# Friends of the San Juans • Whatcom Environmental Council • Sierra Club Washington Conservation Action • RE Sources • Evergreen Islands

RE: SEPA Mitigated Determination of Non-Significance Issued to ALA Energy Liquid Petroleum Gas Terminal for Two New and 31 Prior Unpermitted Projects

ENGO comments re. MDNS issued for ALA Energy Ferndale Terminal - SEPA2024-00052

BOREAL VOYAGER, 08 SEP 2025, Source: Marine Traffic

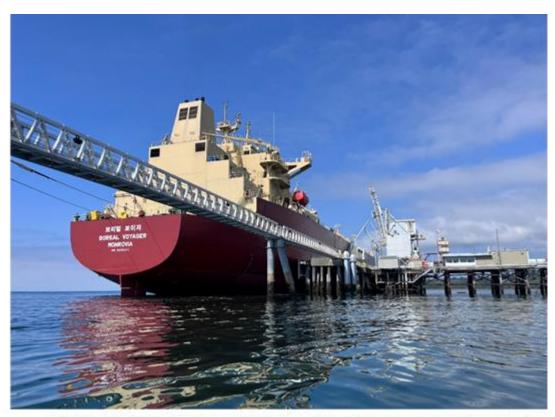
There is also no analysis of the probable significant adverse environmental impact that results in the draft of the Very Large Gas Carriers and the depth of water at the Ferndale Terminal. Ten of the Very Large Gas Carriers under contract have drafts that are **over 40** feet, and the average draft of all the Very Large Gas Carriers under contract is **39.34** feet. In 2020, Petrogas obtained a permit to dredge near the pier to re-establish -38 feet of depth at Mean Lower Low Water to reduce the frequency of deberthing, which must happen at low tide for deeper draft vessels. When this occurs, a "partially laden Terminal Vessel may deberth and transit to the Cherry Point Anchorage or the Vendovi Anchorage..." The environmental checklist and supporting documents do not provide any information about the number of times a vessel has had to deberth, anchor and reberth, and what that impact is on the environment.

Whatcom County failed to consider the impacts of increased vessel traffic originating from nearby terminals, including in British Columbia. For example, the oil tanker P. MONTEREY entered the Salish Sea and arrived at Trans Mountain's Westridge Terminal in Burnaby, BC on August 15, 2025. On August 17, while laden with cargo, the oil tanker transited past the ALA Energy Ferndale Terminal, through Rosario Strait, to the Vendovi Island anchorage area, where it anchored, laden, for seven days. On August 24 - 25, the tanker was at the Phillips 66 Ferndale Refinery, just south of the Ferndale Terminal, and then transited back to the Vendovi Island anchorage area, in ballast (without cargo), where the oil tanker stayed for two weeks, until September 8, 2025.

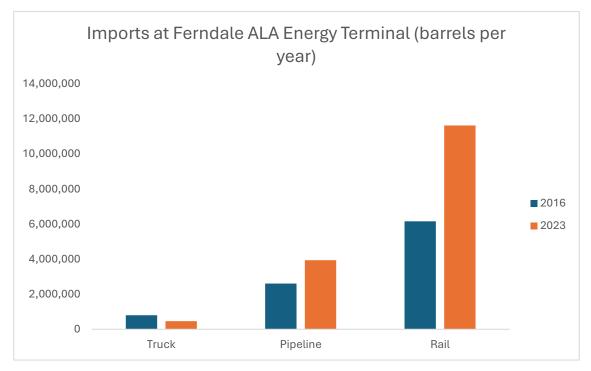
Defining Capacity vs. Throughput: Some of the commenting organizations confused throughput (which is not regulated by the County code) with capacity (which is regulated). To keep it simple, imagine a hotel with 100 rooms. The capacity is 100, but the throughput is how many rooms are actually occupied at any given time. Our projects reduced capacity.<sup>72</sup>

These statements are meant to highlight the fact that capacity, not throughput, is the only permitting concern for Whatcom County. However, throughput and the total amount of propane and butane imported and exported at the Ferndale Terminal, can dramatically impact the environment and should be considered when determining whether an EIS is needed. While the County code addresses capacity, SEPA is concerned with impacts. Our review of the file reveals that the unpermitted projects increase the amount of product handled by the terminal, which has impacts that must be reviewed. The facts on the ground–significantly increased rail and vessel transits since 2016–support this

The total amount of propane and butane barrels (bbl) exported by sector in 2016 and 2023. Data source: ALA Energy, <u>Green House Gas Analysis</u>.

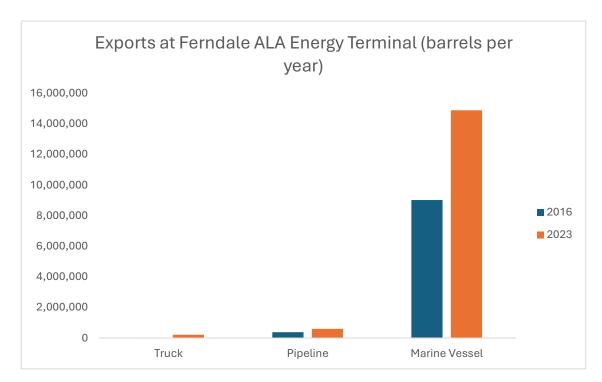
Throughput and the total amount of propane and butane imported and exported at the terminal can dramatically impact the environment and should be considered when determining whether an EIS is needed. The prior unpermitted projects' increase in both capacity and throughput from 2016 to 2023 have been omitted from the environmental review process to date. The increase in capacity may have a probable significant impact on the environment, requiring a threshold determination of significance and preparation of an EIS.
